Block(s): 16 & 17 Section: 13 District/Division: MAWSON

Issue	Date	Amendment
Project		
Multi Unit Housing		
Site		
blocks 16+17		
section 13,		
Mawson, ACT.		
Title		
Site Plan		
Scale	1:200	Drawn By SA
Date	May 2008	Drawing No. 1284 - A
PETER BYFIELD + Associates Suits A, 34 Taylor Street, Ainsworth NSW 2158 Phone 02 9880 2255 Fax 02 9660 2255

Title
Floor Plans Units 6-10

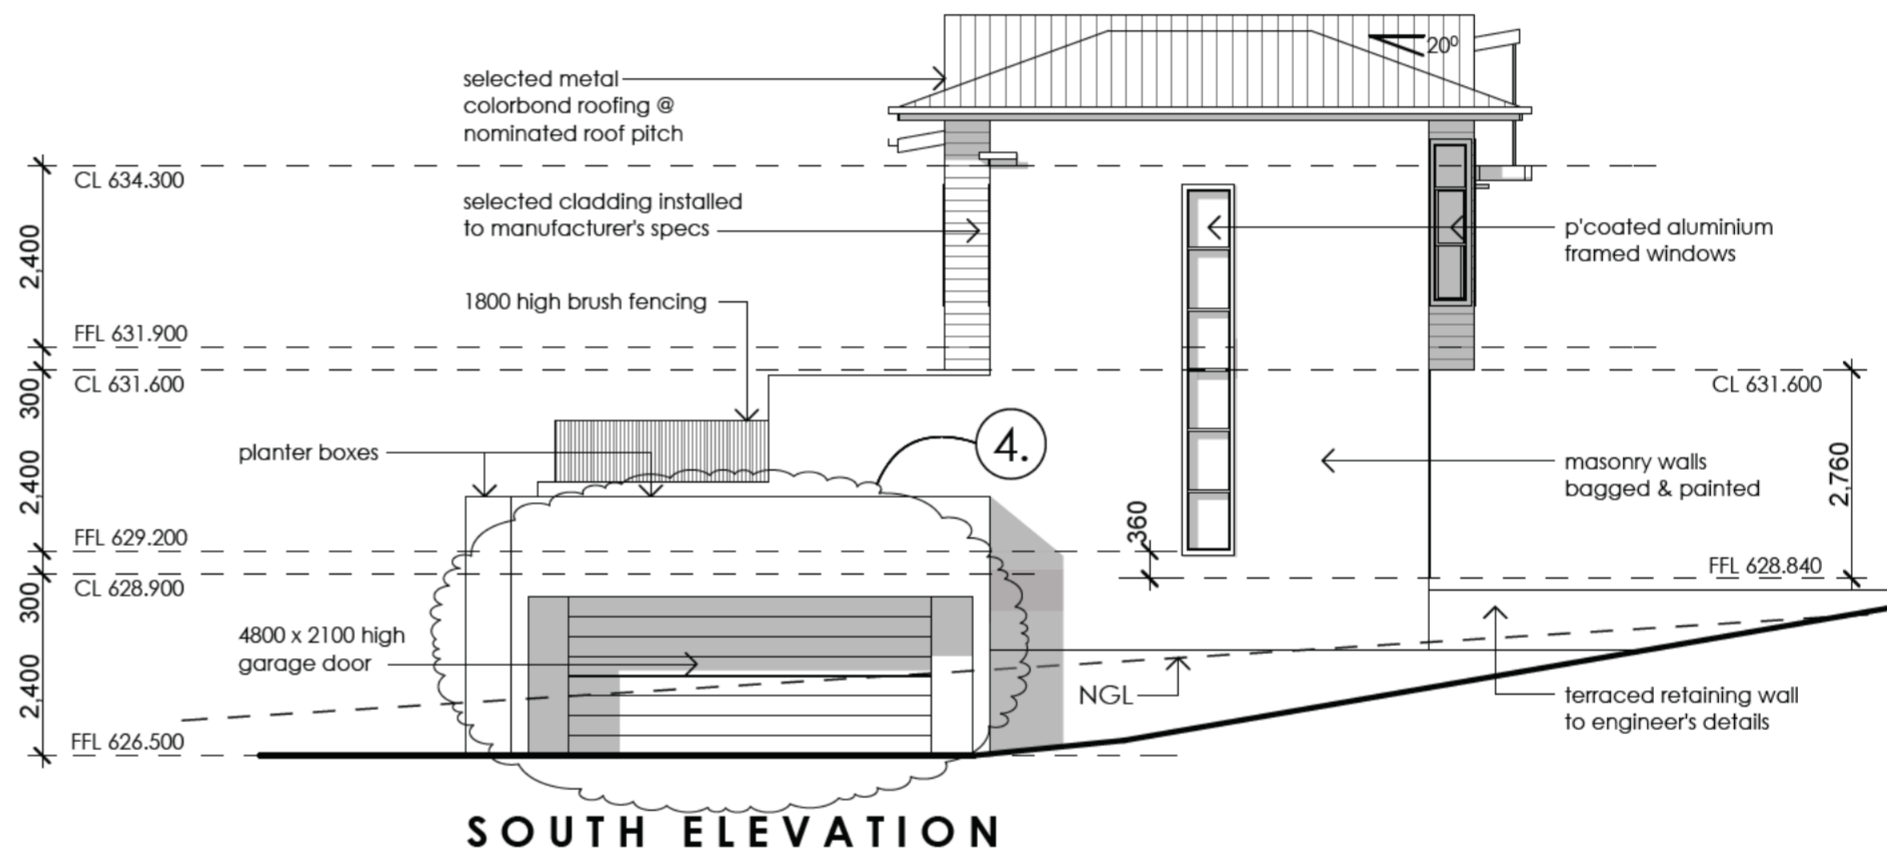
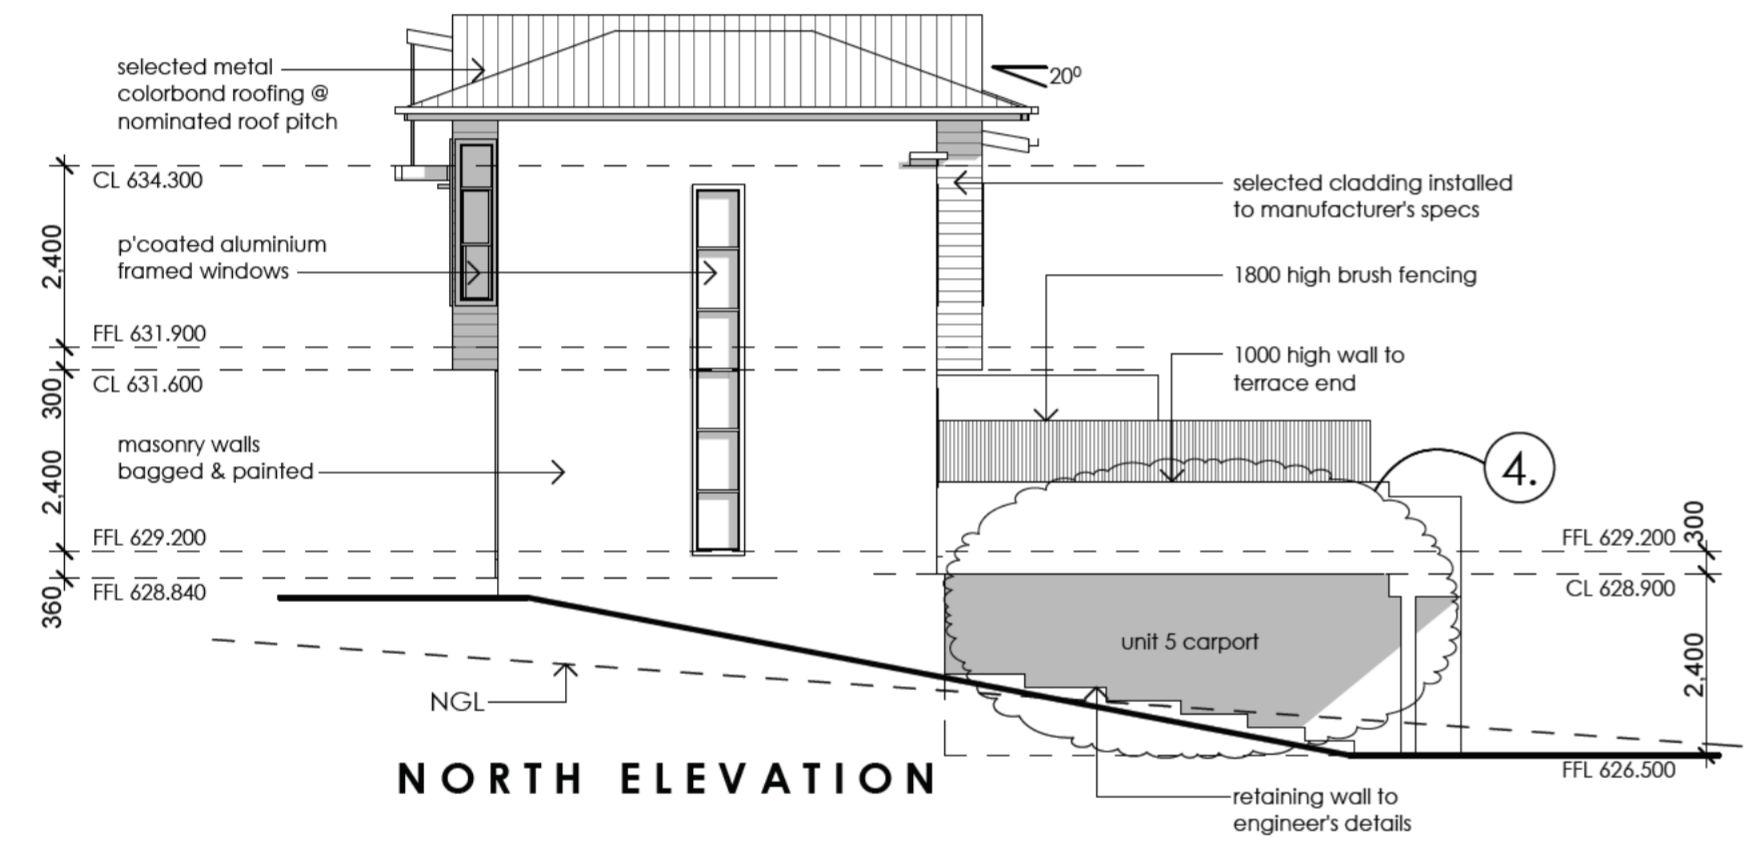
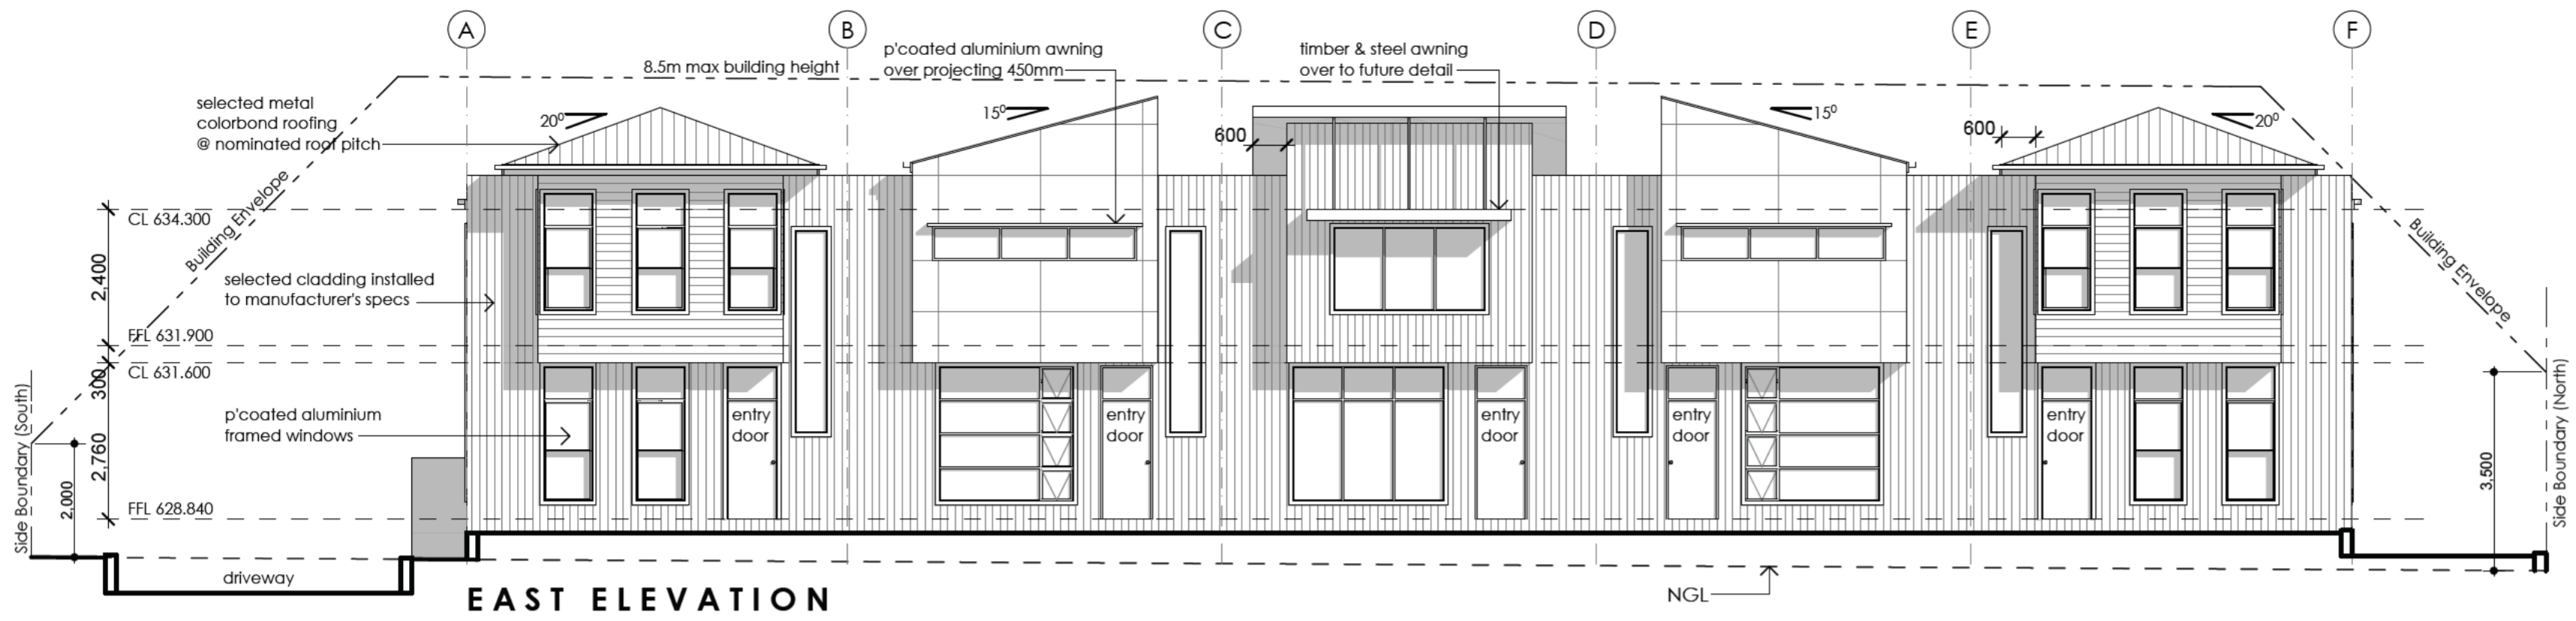
1. Increase floor levels of units 6-9 by 700mm.
2. Create basement parking under units 6-9 (9 spaces) accessed via a vehicular ramp.
3. Relocated unit 10 to achieve a rear setback of 4m.
4. Convert car parking under units 1-5 to allow for 2 car spaces per unit (1-5).
5. Relocated 3 visitor car spaces.
6. Provide enclosure for units 6-9 waste bins.

Scale 1:100	Drawn By SA
Date May 2008	Drawing No. 1284 - D

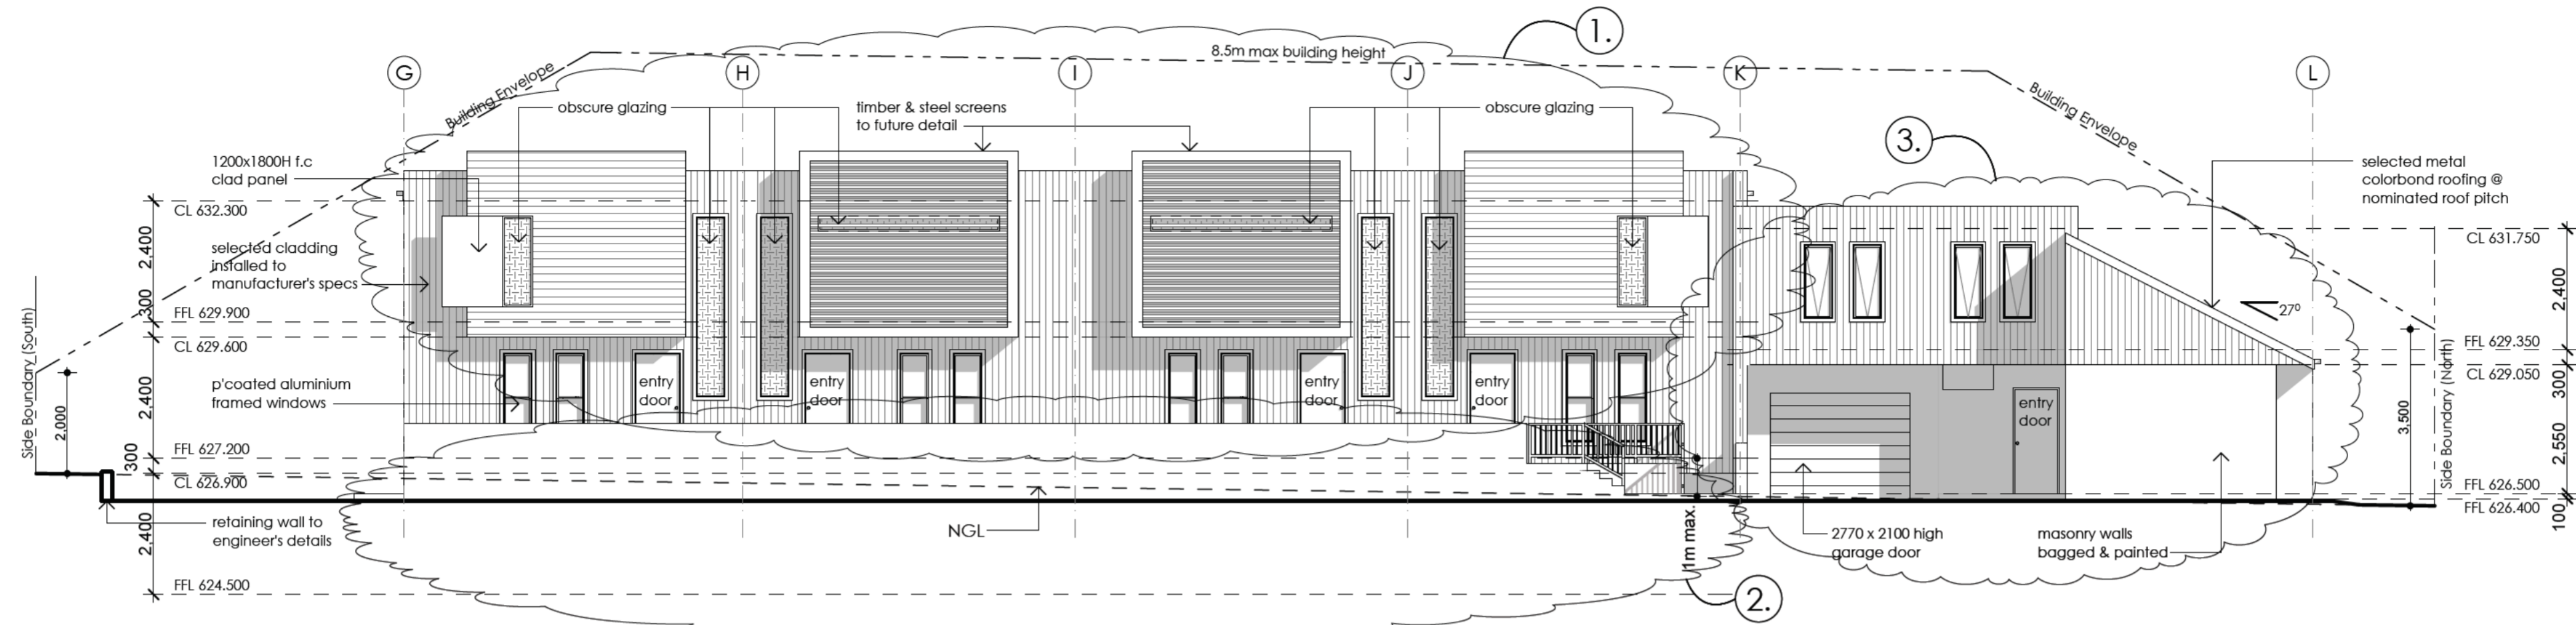
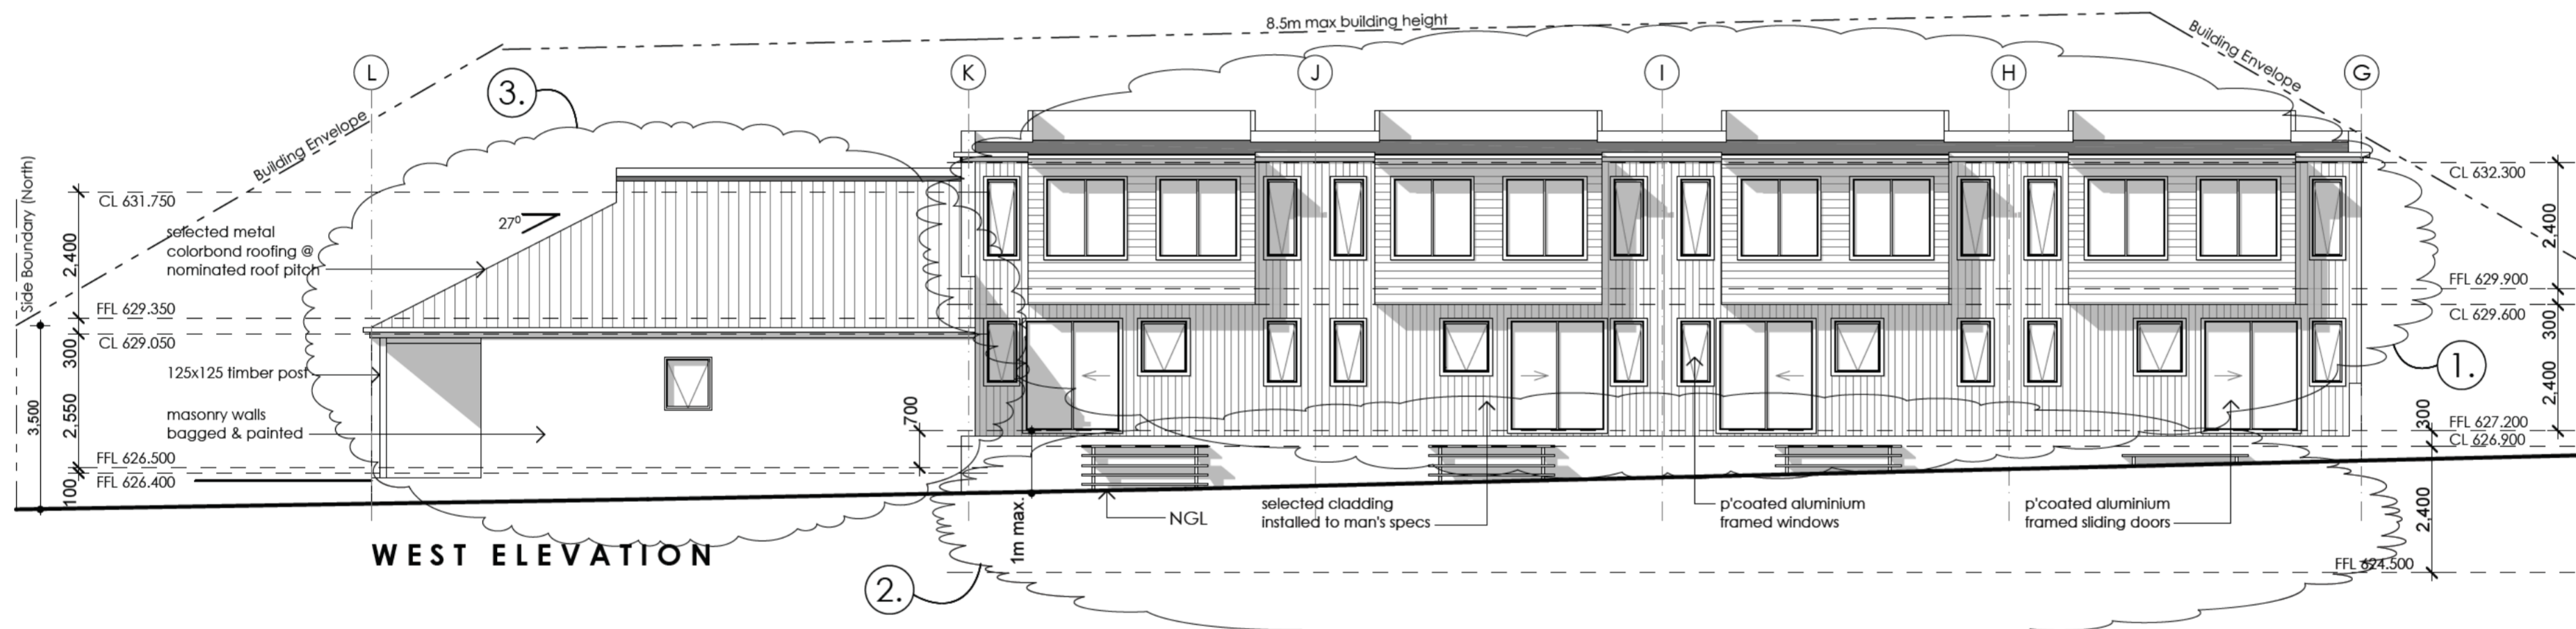
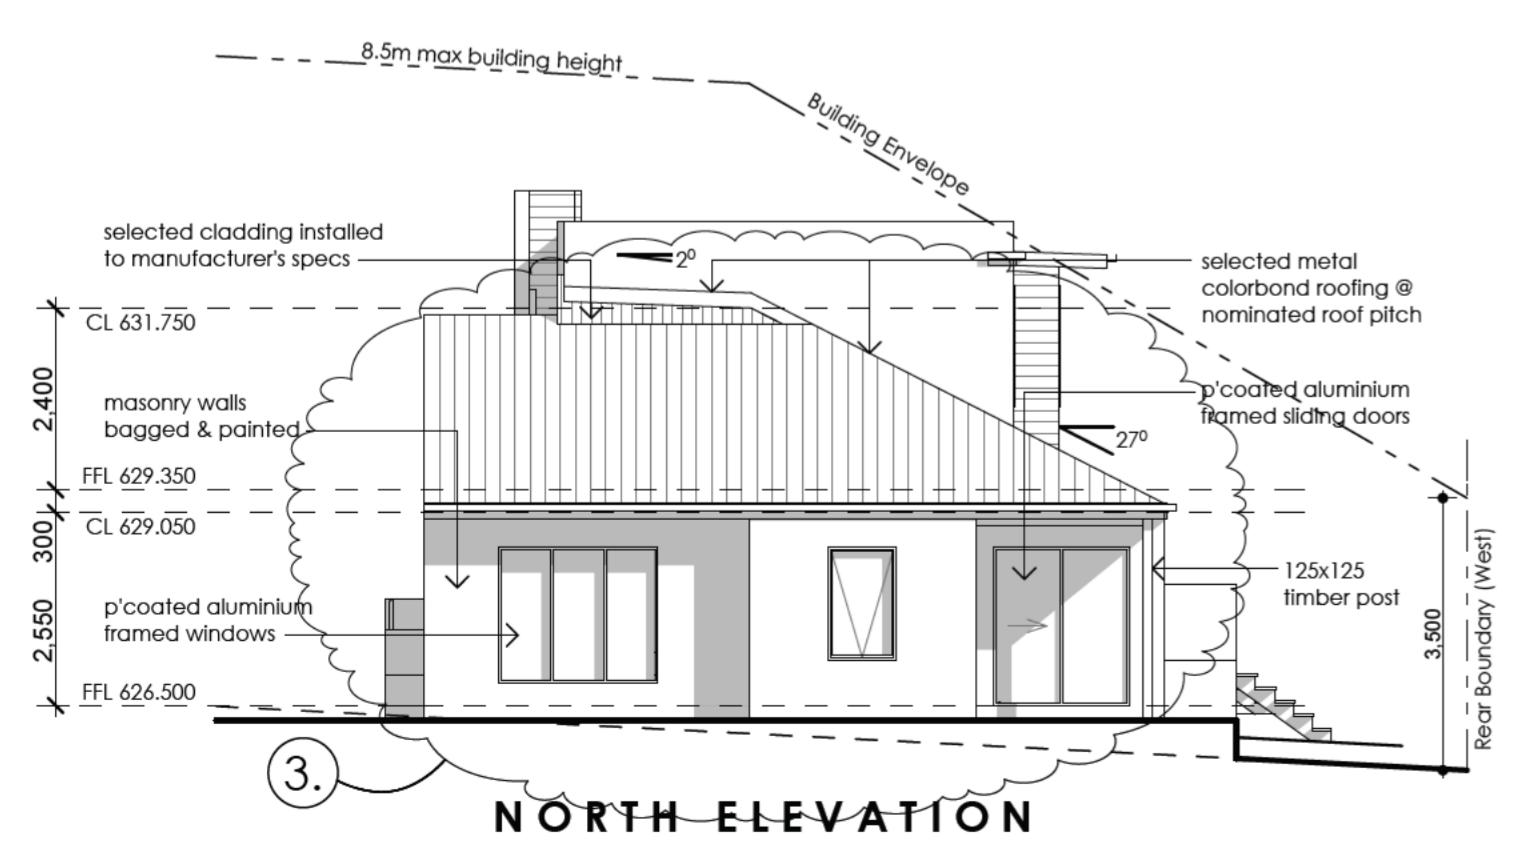
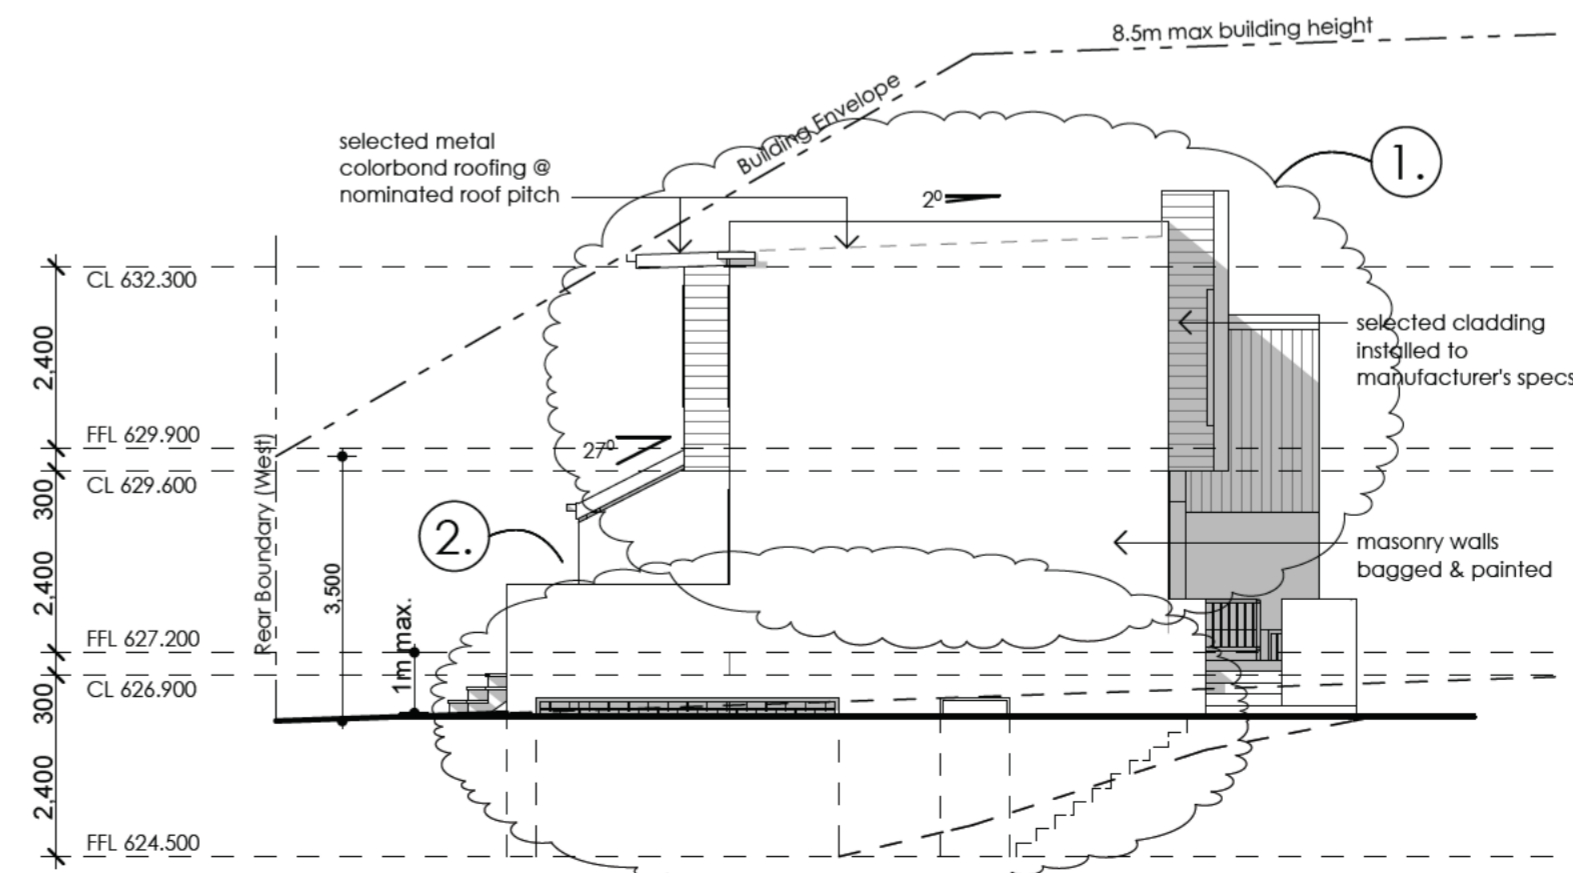
- A** Dec. 2008 Revision
1. Increase floor levels of units 6-9 by 700mm.
 2. Create basement parking under units 6-9 (9 spaces) accessed via a vehicular ramp.

6. Provide enclosure for units 6-9 waste bins.
- | Issue | Date | Event |
